SUBJECT: WELL SITING STUDY - EMERALD BAY

**SUBJECT: Response to Comments on monitoring well design for Black Lake
Well #5 made by Luhdorff and Scalmanini to the County**

**SUBJECT: WELL DESIGN AND SPECIFICATION REVIEW
BLACK LAKE WELL NO. 5
COUNTY OF SAN LUIS OBISPO**

**Review Comments on
General Technical Specifications
for
Drilling, Construction and Testing
of
One Production Well and One Monitoring Well**

Monitoring Well

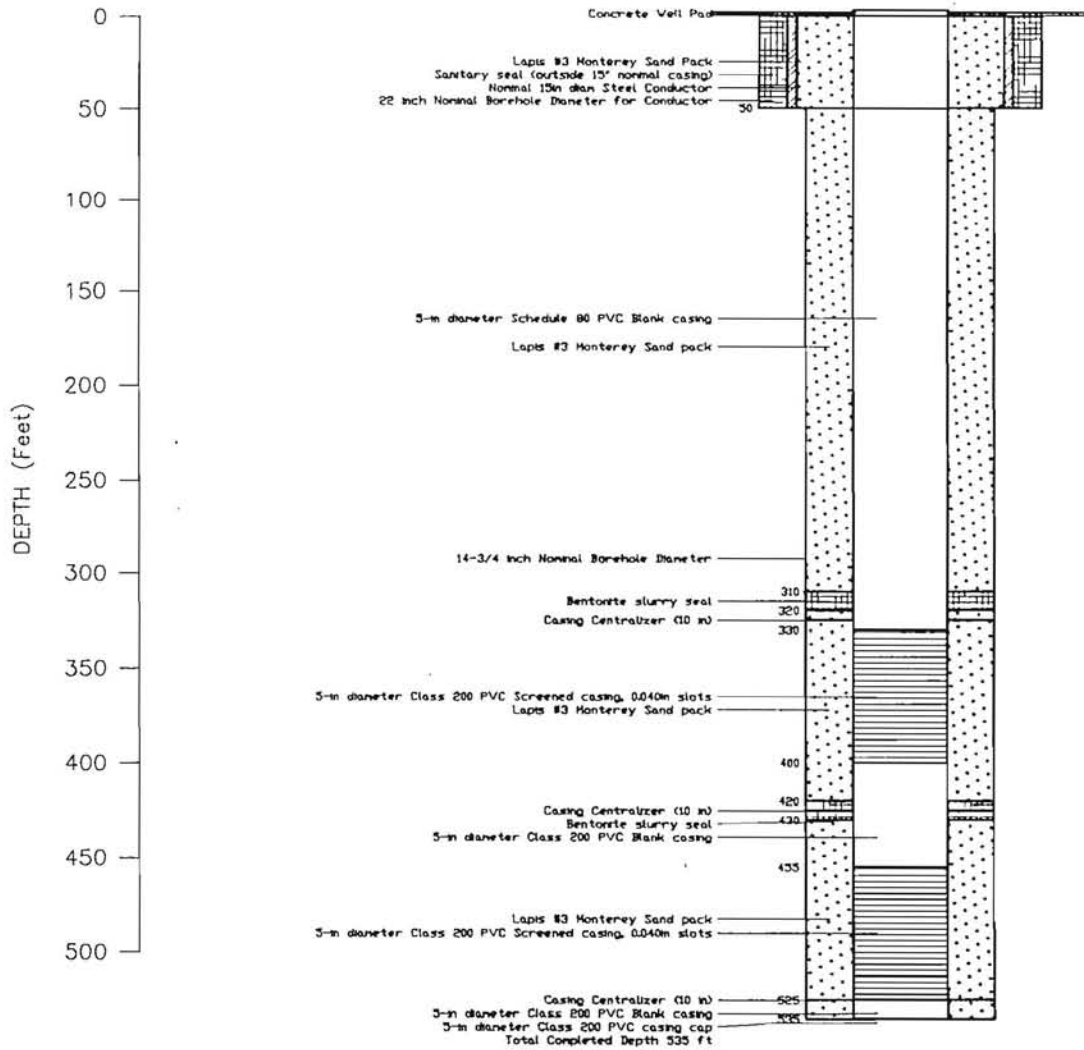
Casing material recommended by Luhdorff & Scalmanini is the Schedule 80 PVC for the entire length of blank and slotted well casing rather than using the Class 200 casing in the screened section. This is acceptable and will be used.

Casing connections are recommended by Luhdorff & Scalmanini to be threaded rather than the solvent weld and stainless steel screw method. The proposed connection using solvent weld and stainless steel screws are industry standard for water well casings and acceptable under state standards.

Annular seals recommended by Luhdorff & Scalmanini include the aquifer isolation seals placed 20 feet above the screen intervals; and the sanitary seal, consisting of cement grout slurry placed in the borehole/monitoring well casing annular space from ground surface to a depth of 230-240 feet. We concur with the placement recommendation for the aquifer isolation seals.

Annular casing centralizers will be placed as recommended by Luhdorff & Scalmanini.

Formation material sieve analysis will be performed as recommended by Luhdorff & Scalmanini.

The monitoring well is to be used for water quality sampling with the main constituents of concern being metals and general mineral ions. The solvent use does not mask analytic results for the constituents to be tested and even with the organic constituents, the solvent consists of tetrahydrofuran which can easily be identified on organic constituent analysis.

Our experience has been that the threaded casing connections result in a weakened point in the casing and a potential for casing failure. Therefore we do not accept the recommended casing connections.

We don't agree with the sanitary seal recommendation for the following reasons. The use of a cement grout slurry in the borehole/casing annulus to a 230-240 foot depth would result in higher collapse pressures than the normal hydraulic gradient and a significantly higher heat of hydration which could weaken the PVC casing. The potential for interaquifer water flow could be precluded by a seal placed at the appropriate depth and would not need to be taken to the surface. If the appropriate depth is at and above 240 feet depth, a seal could be placed there, similar to those placed deeper in the annulus.

We continue to recommend that the conductor casing be placed to a depth of 50 feet with an exterior annular seal as the appropriate sanitary seal for this monitoring well. The conductor casing will protect the monitoring well casing and ensure that the upper portions of the hole are stabilized while construction of the well is in progress. Cost considerations have been dealt with and are not a factor in this special design requirement.
